ENGINEERING CHANGE NOTICE

Proj. ECN B-714-148

5. Project Title/No./Work Order No. GROUTED WASTE DISPOSAL FACILITIES B-714/ER8007	6. Bldg./Sys./Fac. No. 218-E-16	7. Impact Level 3Q/SC-2
	8. Document Numbers Changed by this ECN (includes sheet no. and rev.) SEE BLOCK 12	9. Related ECN No(s). B-714-142	10. Related PO No. N/A
11a. Modification Work <input type="checkbox"/> Yes (fill out Blk. 11b) <input checked="" type="checkbox"/> No (NA Blks. 11b, 11c, 11d)	11b. Work Package No. N/A	11c. Modification Work Complete N/A _____ Cog. Engineer Signature & Date	11d. Restored to Original Condition (Temp. ECN only) N/A _____ Cog. Engineer Signature & Date

REF DWG H-2-77638 SH 2

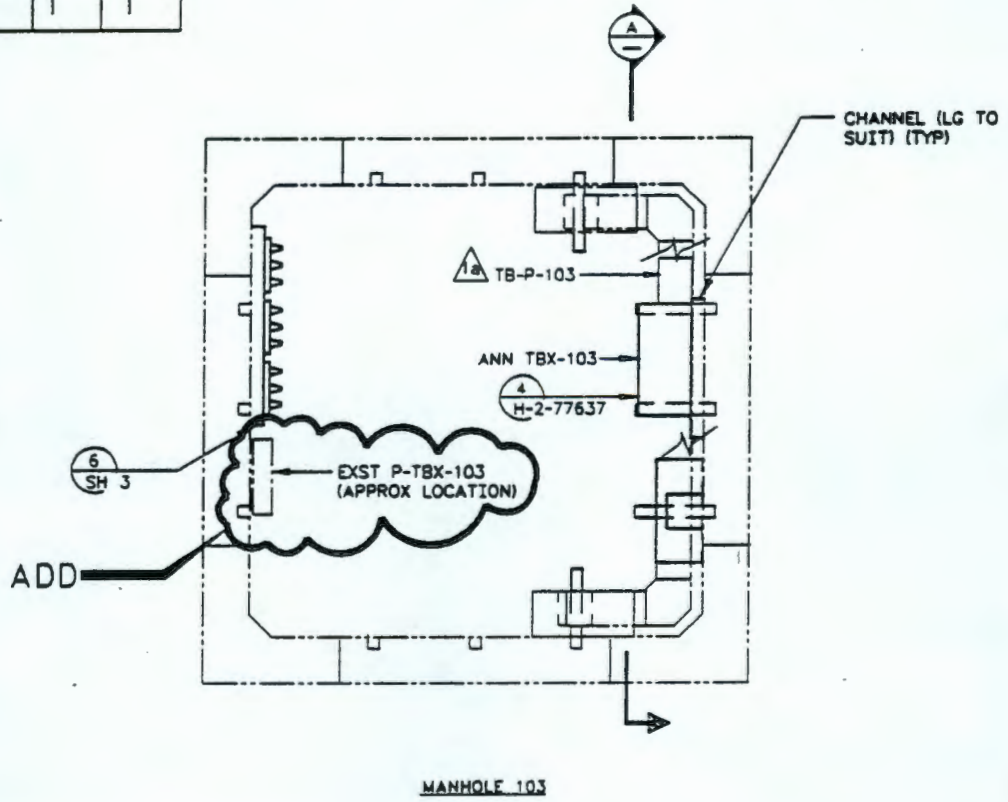
1) H-2-77638 SH 2. REV 1

- A) Section A (Zone C8): Change ANN-TBX to ANN-TBX-102 or -103
Change TB-P-102 to TB-P-102 or -103
- B) Manhole 103 Plan (Z E6): Add EXST P-TBX-103 as shown on page 5 of this ECN.

REF DWG H-2-78509 SH 1

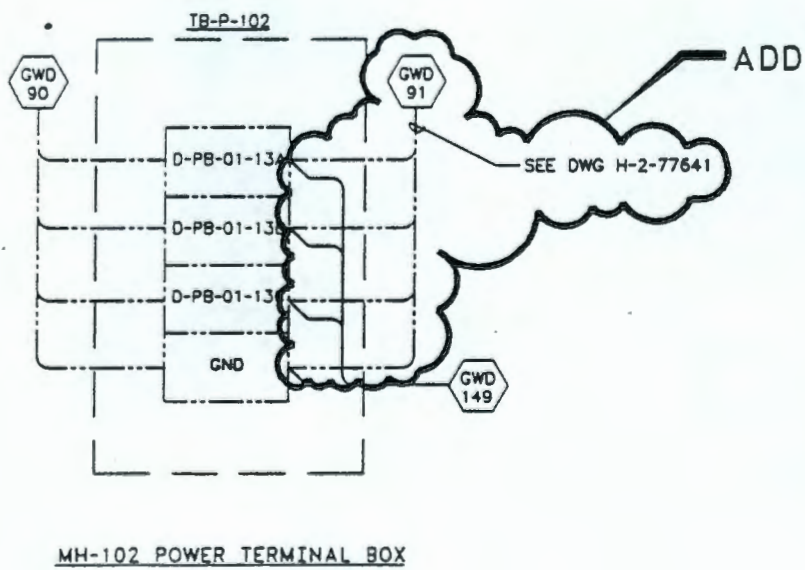
5) H-2-78509 SH 1. REV 1

- A) Manhole 102 Power Terminal Box (Z A3-B4): Revise as shown on page 5 of this ECN.
- B) Manhole 103 Power Terminal Box (Z A-B4): Delete wire from terminal D-PB-01-13C on wire run GWD87

Ref. Dwg. H-2-77643	Sh. 1	Rev. 1	Prepared By TE COYNE	Checked By <i>A. R. Snowhite</i>	ECN No. B-714-148	Page 6/6
------------------------	----------	-----------	-------------------------	-------------------------------------	----------------------	-------------

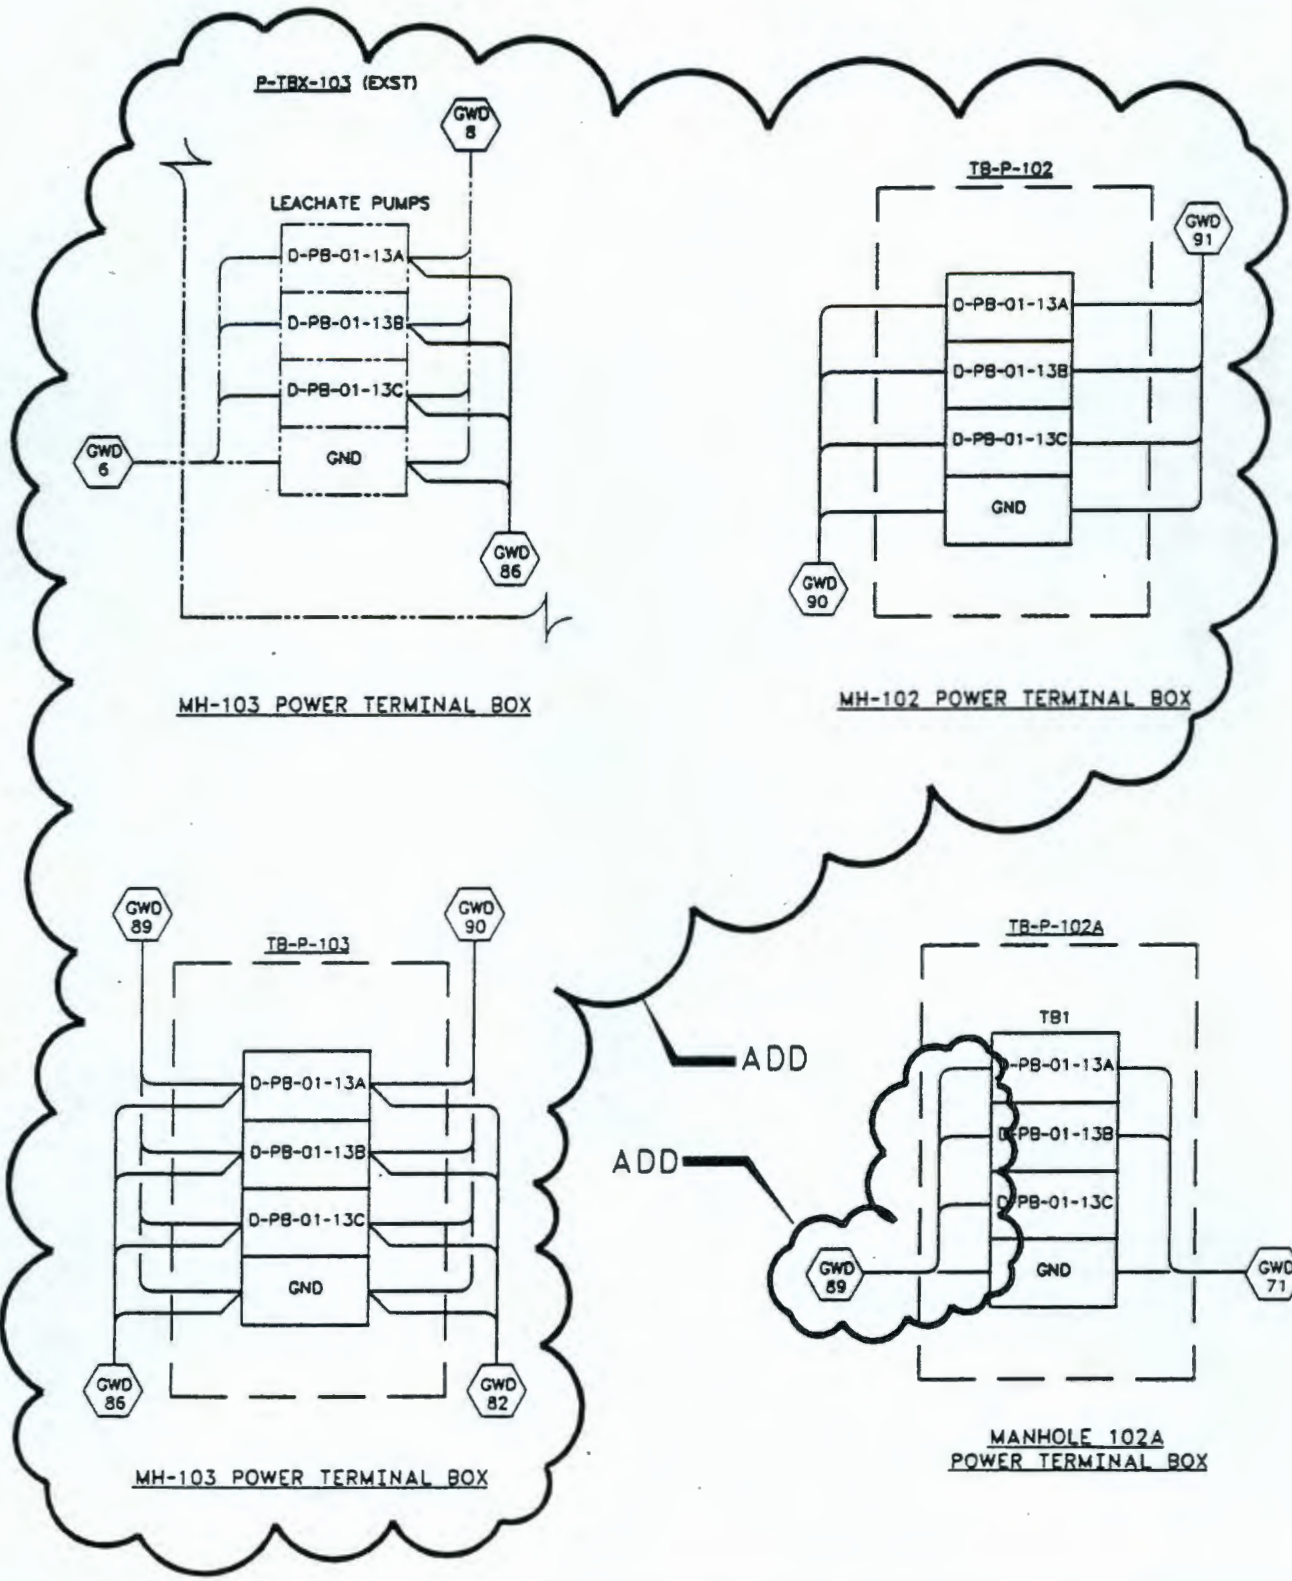
3) H-2-77643 SH 1. REV 1

- A) Manhole Power Terminal Box (Z B-C3): Delete in its entirety.
- B) Add terminal box wiring diagrams as shown on page 6 of this ECN.
- C) Manhole 102A Power Terminal Box (Z C1-D2): Revise as shown on page 6 of this ECN.
